Access Compliance Report

Public Rights-of-Way

Intersection ID: 2596	Main Street: FAIRVISTA_DR	Cross Street: KNIGHTSGATE_CT	Location: SE
ADA ID: 2BF4CFE46B1D	Ramp Type: PerpDiag	Initial Pass/Fail: Fail	Overall Compliance: No
Severity Score: 8.75			
Codes/Mitigation Info/Possible Solution		Field Measurements/Component Compliance

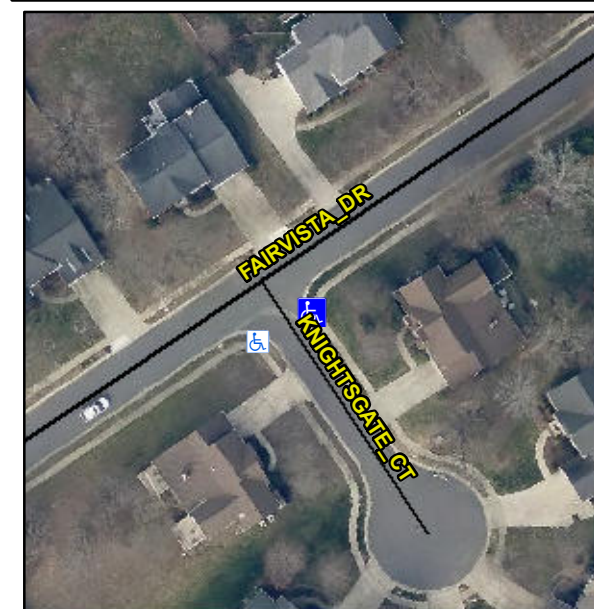
Not Found, R304.5.1

Compliance	Description	Data	Compliance	Description	Data
N/A	Ramp Length (in)	45.5	Yes	Ramp Slope (%)	7.3
No	Ramp Width (in)	41.0	Yes	Ramp XSlope (%)	0.3
N/A	Flare Type LT	N/A	N/A	Flare Type RT	N/A
N/A	Flare Slope LT (%)	N/A	N/A	Flare Slope RT (%)	N/A
N/A	Flare Traversable LT?	N/A	N/A	Flare Traversable RT?	N/A
N/A	Landing Length (in)	N/A	N/A	DWS Provided?	N/A
N/A	Landing Width (in)	N/A	N/A	DWS Contrast?	N/A
N/A	Landing Slope (%)	N/A	N/A	DWS Length (in)	N/A
N/A	Landing X Slope (%)	N/A	N/A	DWS Full Width?	N/A
N/A	Landing Curb? (Y/N)	N/A	N/A	DWS Offset (in)	N/A
N/A	Shared Landing?	N/A			
N/A	Gutter Ponding?	N/A	N/A	Gutter Slope (%)	N/A
N/A	Gutter Lip Ht (in)	N/A	N/A	Gutter X Slope (%)	N/A
N/A	Painted X Walk1?	No	N/A	Painted X Walk2?	No
	X Walk 1 Direction	To N		X Walk 2 Direction	To W
N/A	X Walk 1 Width (in)	N/A	N/A	X Walk 2 Width (in)	N/A
	X Walk 1 Slope (%)	3.9		X Walk 2 Slope (%)	0.6
	X Walk 1 X Slope (%)	3.9		X Walk 2 X Slope (%)	0.7

Remove & Replace Curb Ramp With Two New Directional Ramps or Equivalent.
